# Dual-signature LLDP v111

**Lennart Yseboodt**

Philips Lighting – Research

June 20, 2017

## Summary

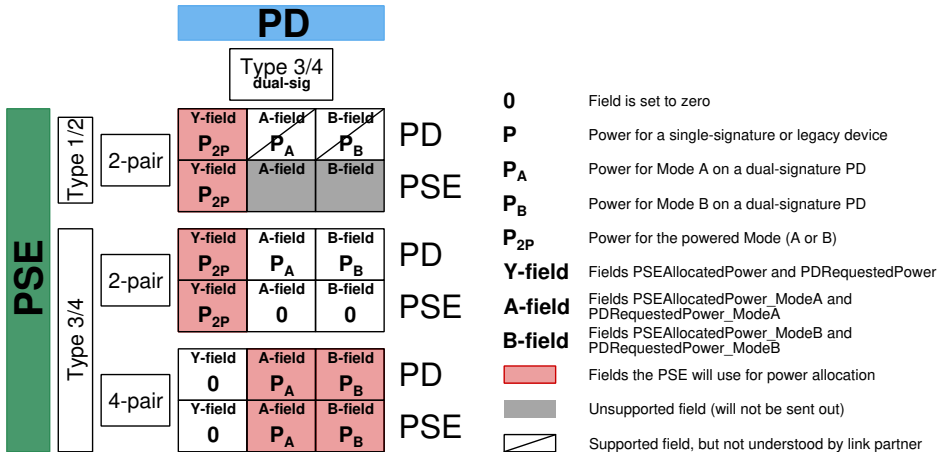
The core change compared to D2.5 is that fields that are not applicable, are set to zero. This prevents duplicate information being sent. Duplicate fields have potential to confuse.

Another change would be to allow dual-signature PDs to request power on a pairset that is unpowered. This is a valid use-case, currently disallowed by a requirement.

Plan is to provide normative requirement in one subclause on how to fill out the fields depending on the situation. State machines may need some tweaking to match with the desired behavior.
